# NEW & IMPROVED SASH GASKET

## INTRODUCING THE NEW & IMPROVED SASH GASKET HK705

June 2019  
Technical Bulletin  
[www.hbs.co.za](http://www.hbs.co.za)

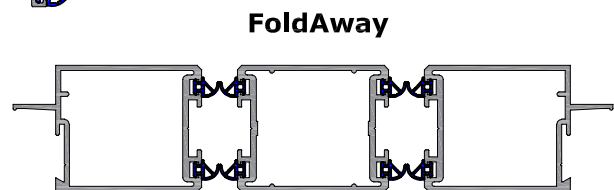
The HK705 Sash gasket will replace the HK704 Sash gasket.

- Wider base and less chance of pull-out
- 100% UV-resistant EPDM material
- Lower cost
- Tighter product tolerances
